**Re: Proposed Starbucks
944 South Main Street
Cheshire, Connecticut
SLR #141.17378.00001.0040**

Please find attached a revised site development plan set that was approved by the Cheshire Planning and Zoning Commission. These plans show a bioretention basin in the 50-foot upland review area on the east side of the property adjacent to the Mill River that was not shown on the design plans referenced in the Cheshire Inland Wetlands and Watercourses Commission (CIWWC) permit letter issued on January 25, 2021. This bioretention basin was requested by the Regional Water Authority in a review letter from Mr. Ron Walters to the Cheshire Planning and Zoning Commission dated December 10, 2020. The basin was requested to enhance stormwater quality treatment from the adjacent building and paved areas prior to discharge to the Mill River. The basin also provides flood storage volume to mitigate proposed filling in the Federal Emergency Management Agency (FEMA) 100-year floodplain. The design of the bioretention basin and floodplain storage computations not completed at the time of the CIWWC decision.

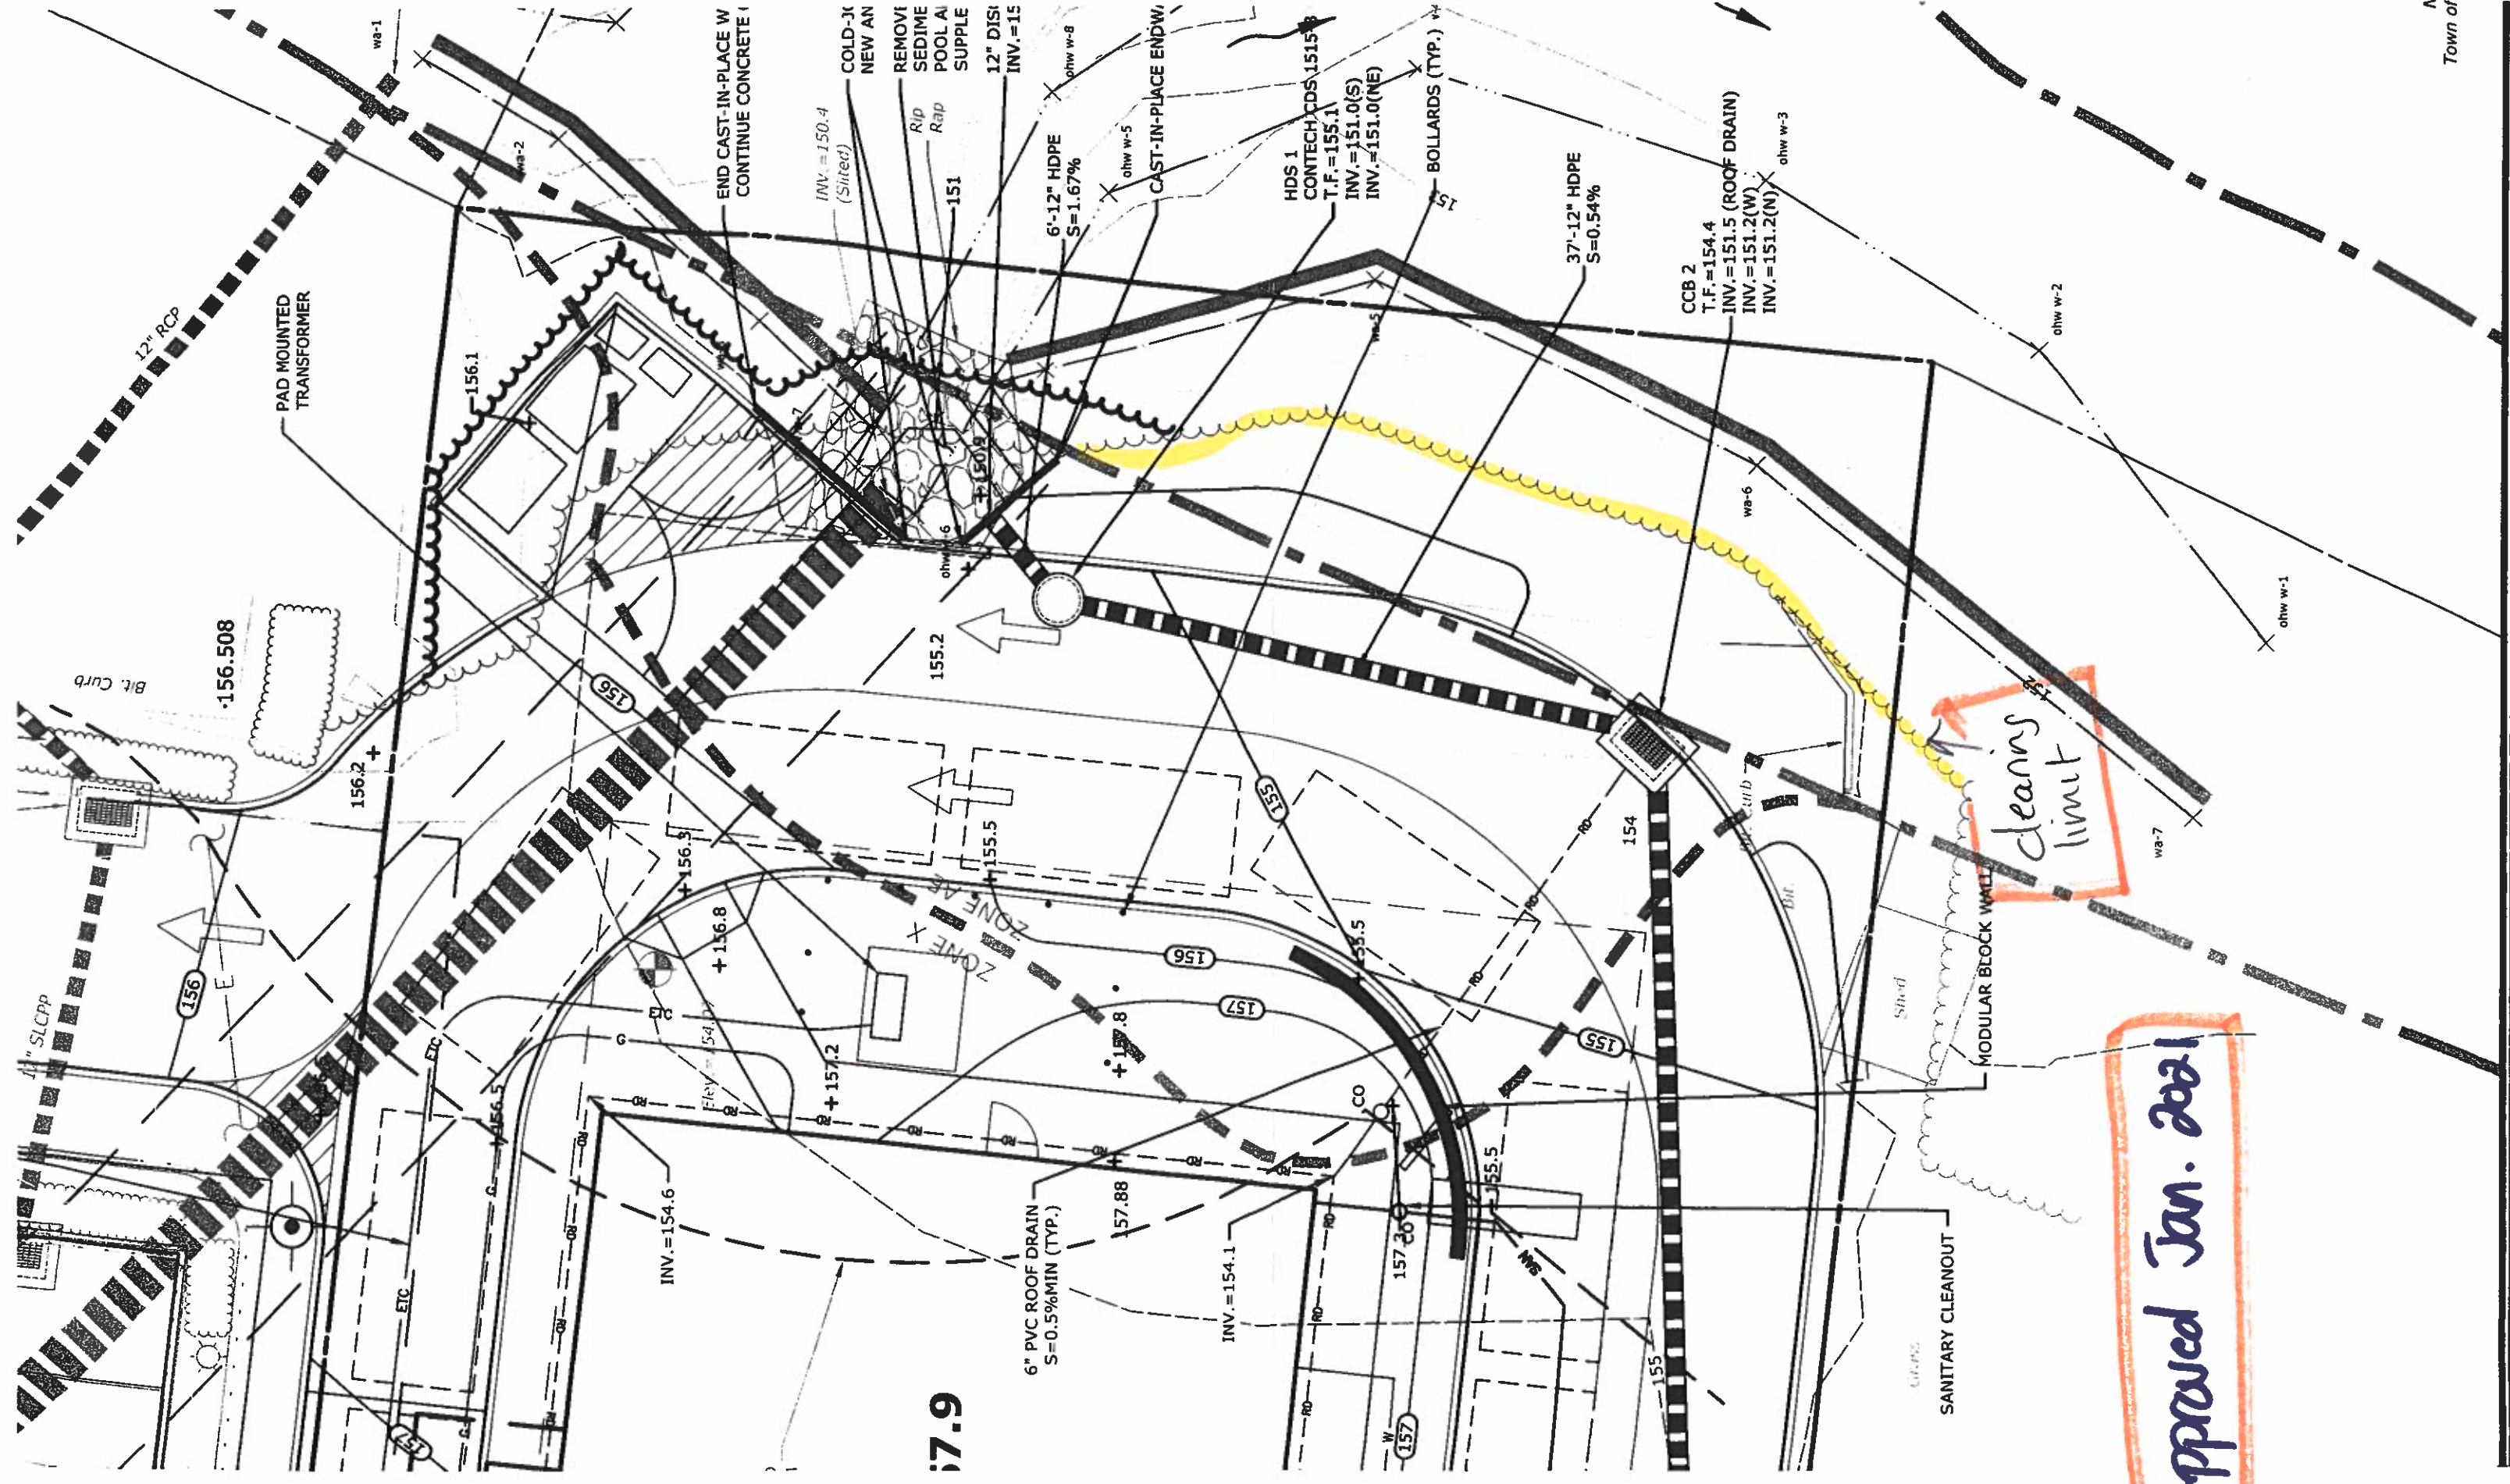
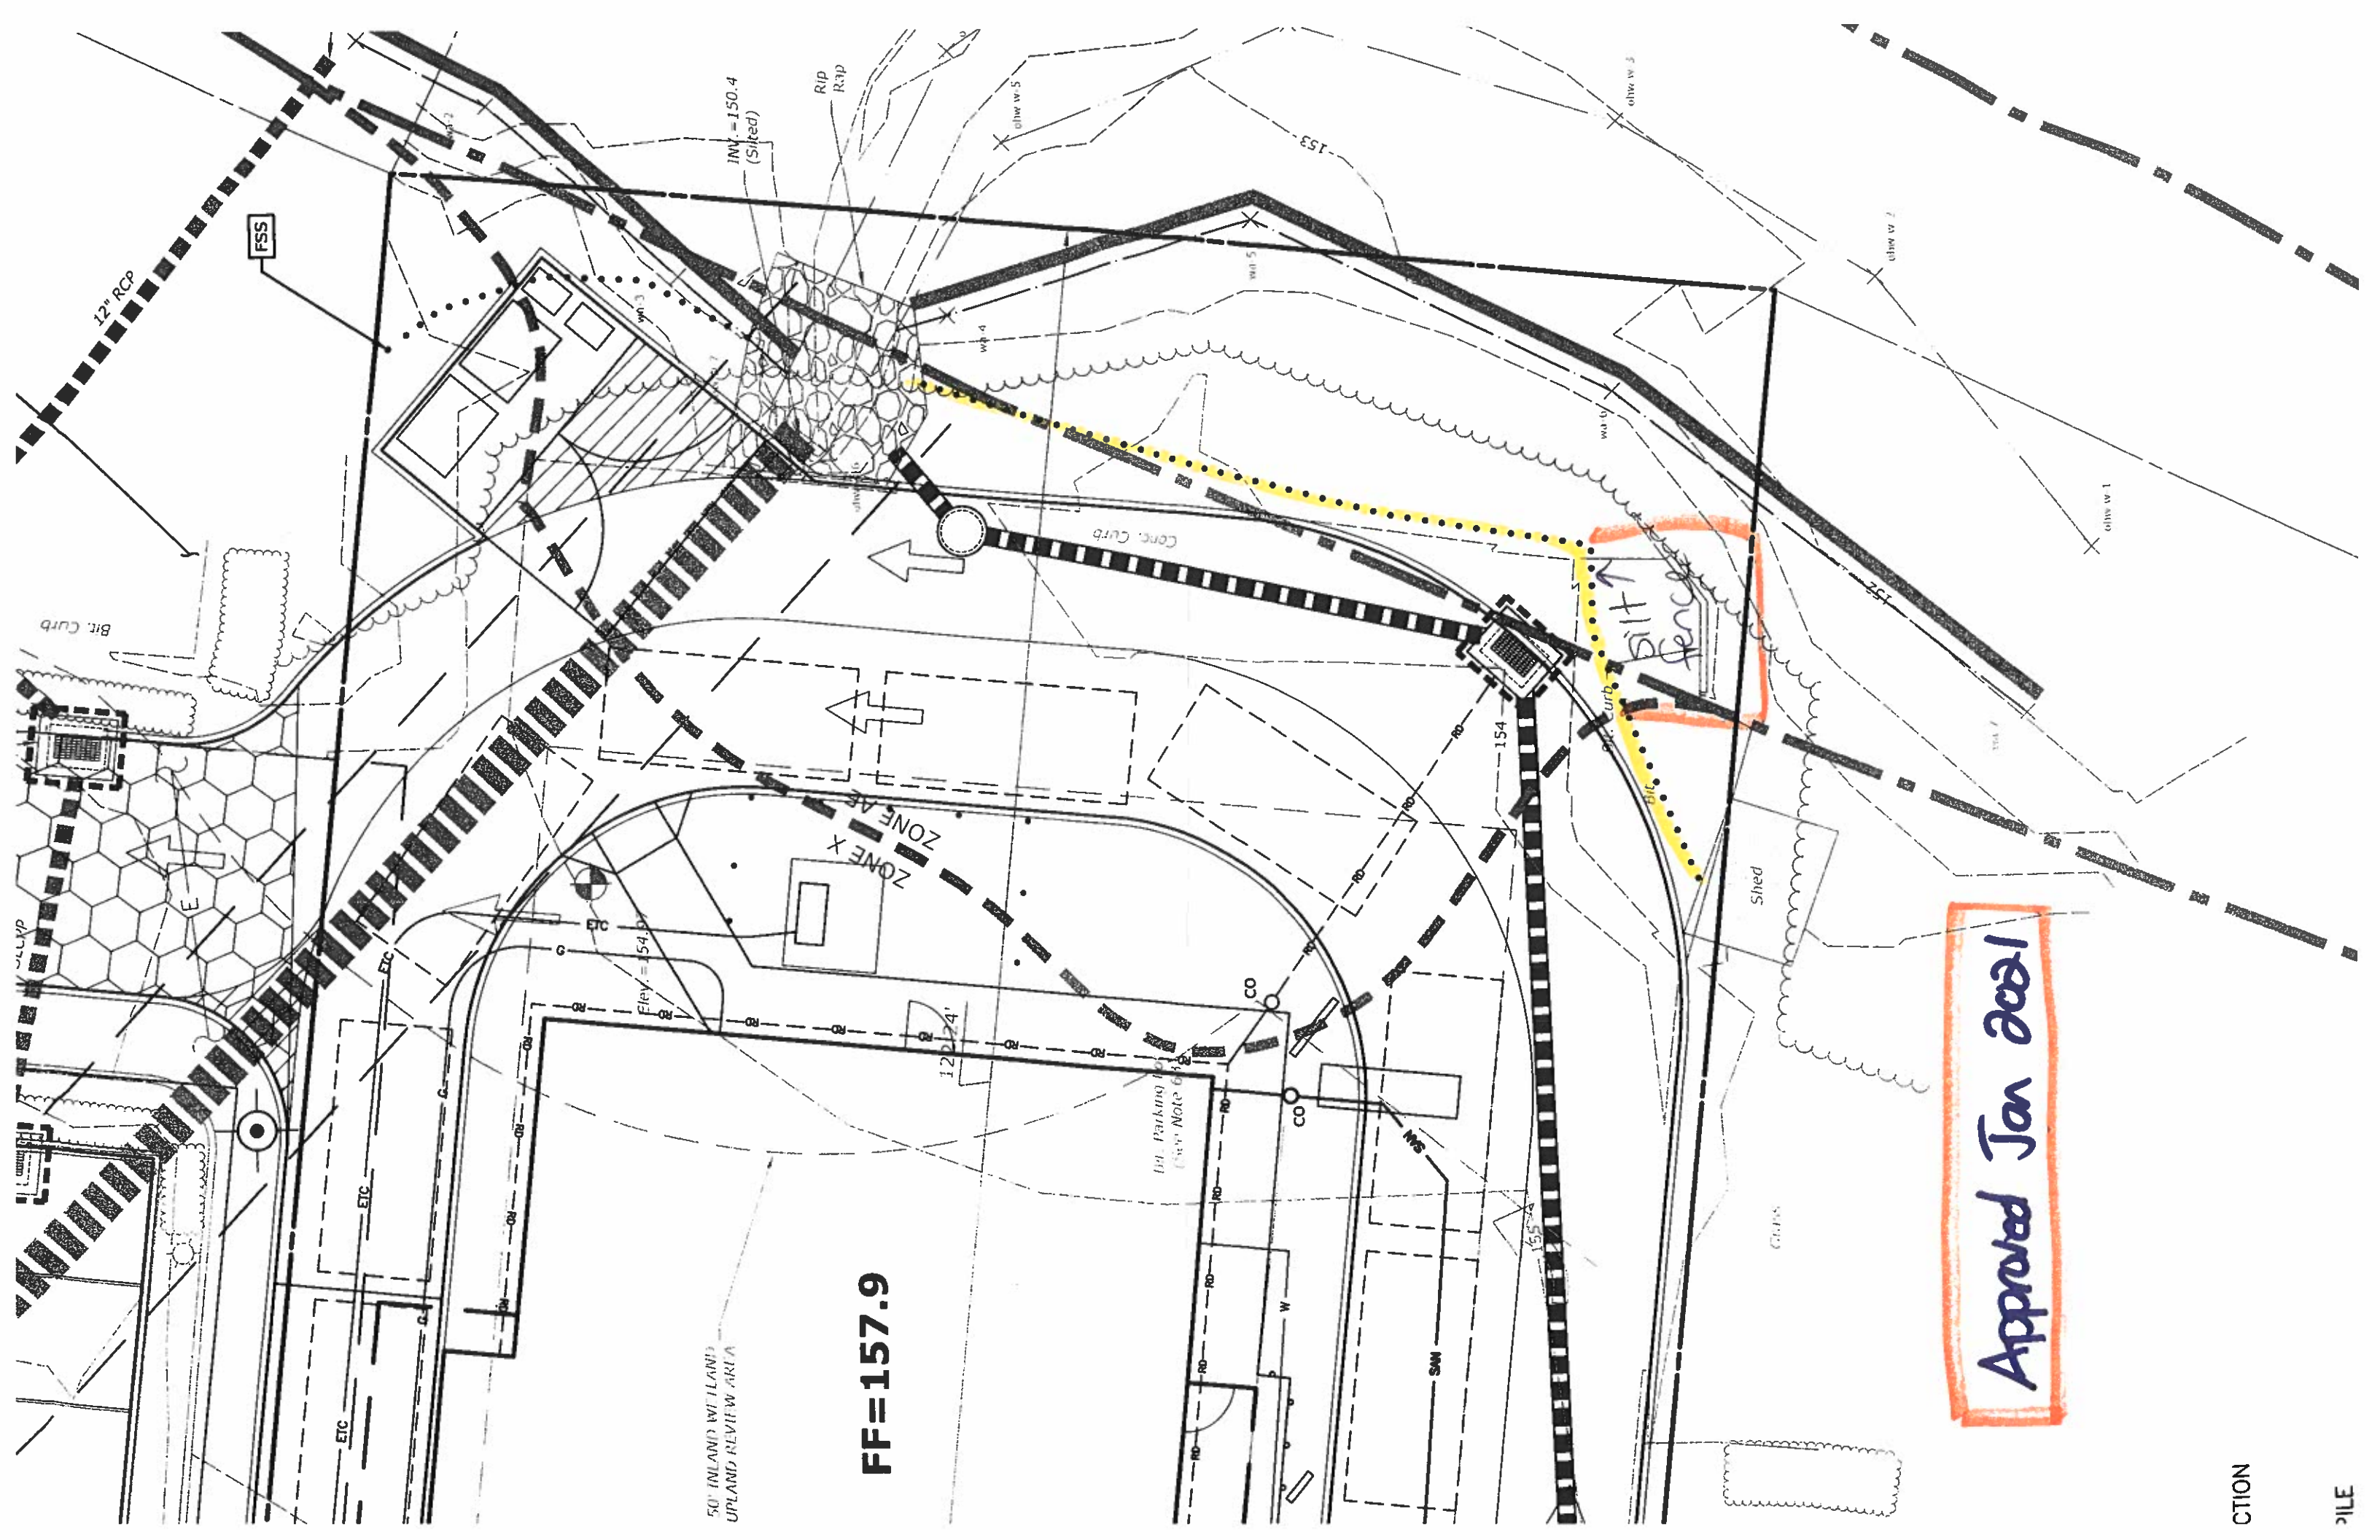
While the permitted upland review area disturbance does not change, the grading and proposed plantings have changed to accommodate the bioretention basin. We are submitting these plans for review so that CIWWC is aware of the change and that both permit files are complete. Therefore, we are requesting that the Commission review these plans as a permit determination to confirm that the plan as proposed does not represent a new impact that would require a modification of the permit. However, should a permit be needed, an updated application is also attached.

BIORETENTION BASIN
SEE DETAIL
